Re: Florida Power Corporation  
Crystal River Unit #3  
Docket No. 50-302

SUPPLEMENT 1

NRC COMMENTS TO THE CRYSTAL RIVER #3

REACTOR BUILDING DOME DELAMINATION REPORT

## ATTACHMENT 2 FOR ANSWER TO QUESTION 2.4(1)

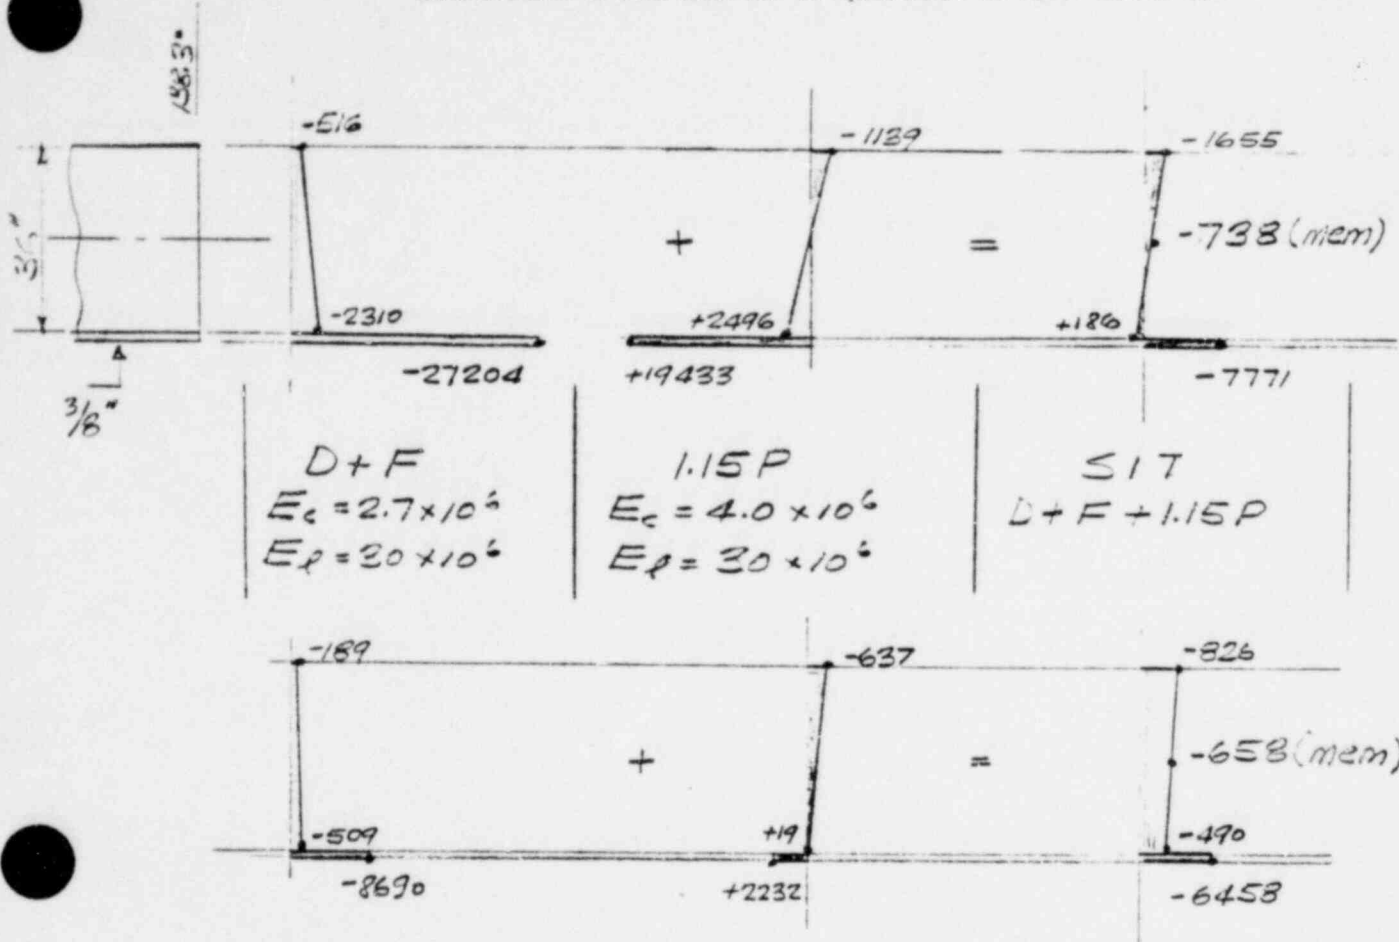
1. In the paragraph in the middle of Page 2-4, you indicated that for structural integrity test and accident condition load combinations, stresses for sustained loads cannot be combined with those due to rapidly applied loads internally in the program and are combined externally. Provide an example of actual design to show how the stresses are combined externally and illustrate the combination on a stress-strain diagram.

EXAMPLE OF SIT CALCULATION

24" DOME SIT

Ref: Figs 4-14 thru 4-17

$$\begin{array}{lll} E_c = 2.7 \times 10^6 & \nu_c = 0.20 & D+F \\ E_c = 4.0 \times 10^6 & \nu_c = 0.20 & 1.15P \\ E_s = 30 \times 10^6 & \nu_s = 0.30 & \end{array}$$

## ATTACHMENT 3 FOR ANSWER TO QUESTION 2.4(4) - CREEP

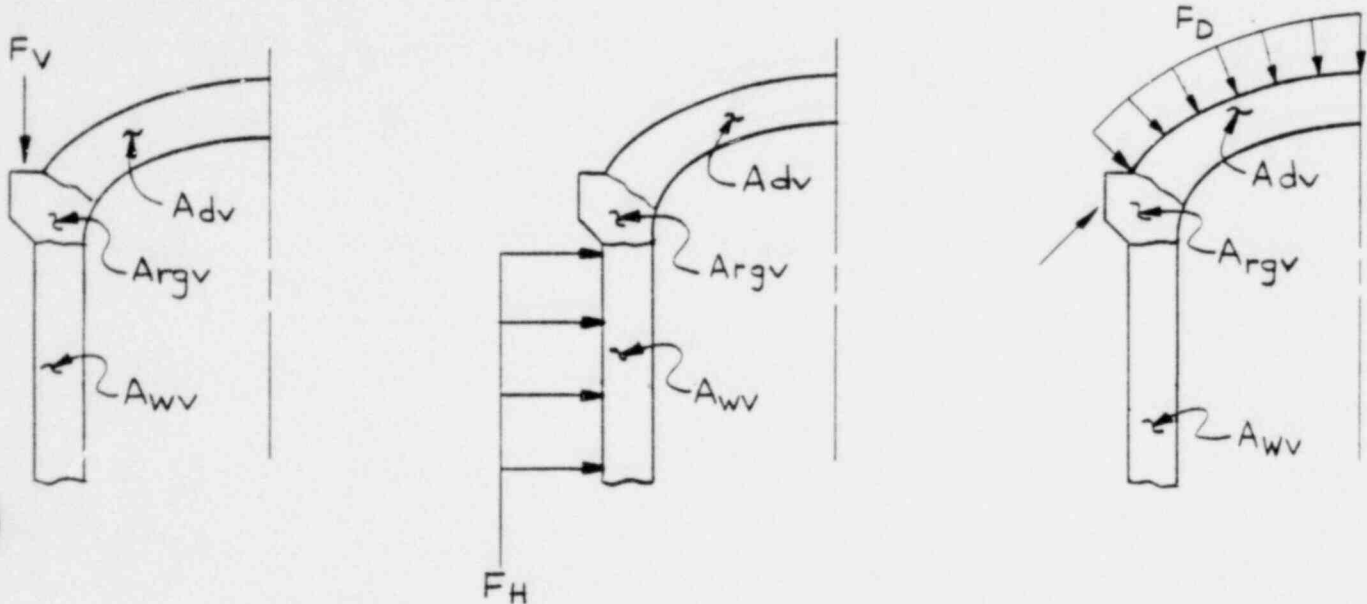
4. Discuss in detail the effects of creep, including the following consideration:

Because of the different level of prestress in the wall in the vertical direction, the wall in the hoop direction, in the ring girder and in the dome the  $E'_c$  is different in all these directions and this effect should be considered in the analysis. The wall acts as an orthotropic element. The different parts of the structure have simultaneously different  $E'_c$  due to different specific creep.

With respect to liner stresses and strains, the structural analyses show that the  $E'_C$  effect ( $E'_C = 2.7 \times 10^6$  @ present and  $E'_C = 1.8 \times 10^6$  @ 40 yr versus  $E_C = 4 \times 10^6$  - "instantaneous") is much greater than that of the reduced tendon force. The net result is liner stresses and strains which have compressive values much greater than those which occur at initial prestress. The liner strains in the report include this.

A third effect of concrete creep is to produce creep induced stresses which result only when the  $E'_C$  is not uniform over the containment structure. If  $E'_C$  is uniform, the stresses at any time are equal to those at initial prestress less tendon losses, in the case where the liner is not part of the model.

ATTACHMENT FOR ANSWER TO QUESTION 3.3(3)

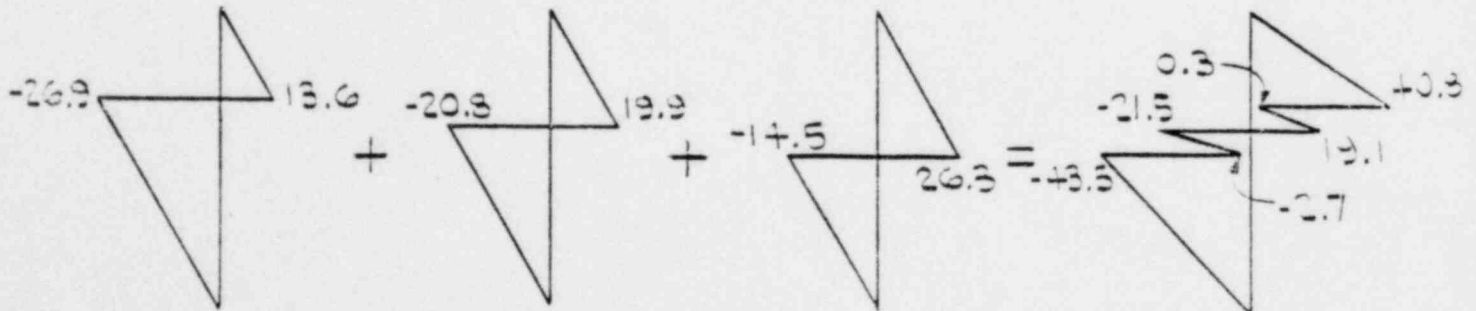
3. Provide the hand calculation which you made to obtain the radial tension.

The radial tension are hand-calculated as follows:

Tendon force at 0.7 ultimate = 1633<sup>k</sup> tendon spacing 30"

$$\text{Top Tendon } \sigma_1 = \frac{1633 \times 1000}{30 \times 1343.9} \times \frac{12.1}{36} = 40.5 \times \frac{12.1}{36} = 13.6 \text{ psi}$$

$$\text{Middle Tendon } \sigma_2 = \frac{1633 \times 1000}{30 \times 1338.4} \times \frac{17.6}{36} = 40.7 \times \frac{17.6}{36} = 19.9 \text{ psi}$$

$$\text{Bottom Tendon } \sigma_3 = \frac{1633 \times 1000}{30 \times 1332.8} \times \frac{23.2}{36} = 40.8 \times \frac{23.2}{36} = 26.3 \text{ psi}$$

The radial tension due to all three layers of tendon are superimposed as follows

ATTACHMENT FOR ANSWER TO QUESTION 3.3(6)

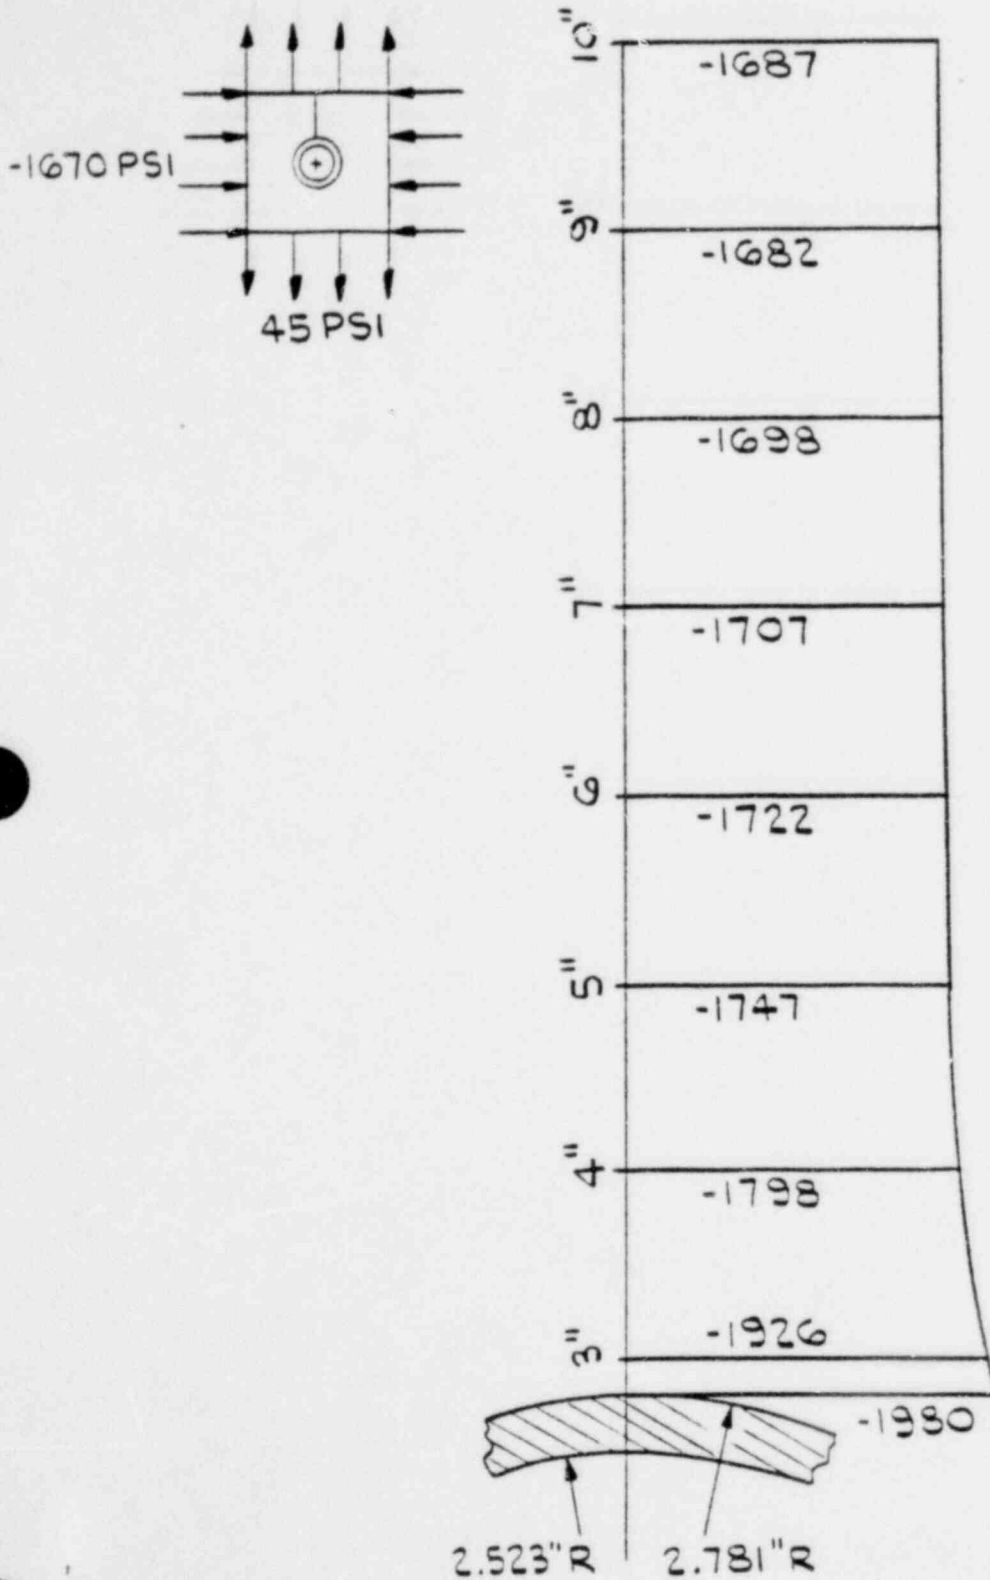
6. When the effect of tendon conduits is analyzed, it should be noted that this effect is different when evaluated in the direction parallel to the tendon and orthogonal to the tendon. In the direction parallel to the tendon a 1/4" thick pipe (5"Ø) approximately replaced the removed concrete. But in the direction perpendicular to the tendon, the pipe introduces a flexible link which modifies the average properties of the concrete section.

Answer: We have reviewed the effect of the conduit on stresses following a path 90° from the stress profile shown in Figure 3-18. The distribution shown in attachment indicates that the effect will not be significant. However, the effect on conduits are conservatively represented by a concrete layer with equivalent Young's modulus calculated by the ratio of net concrete volume to gross concrete volume.

STRESS PROFILE 90° AWAY FROM FIG. 3-13
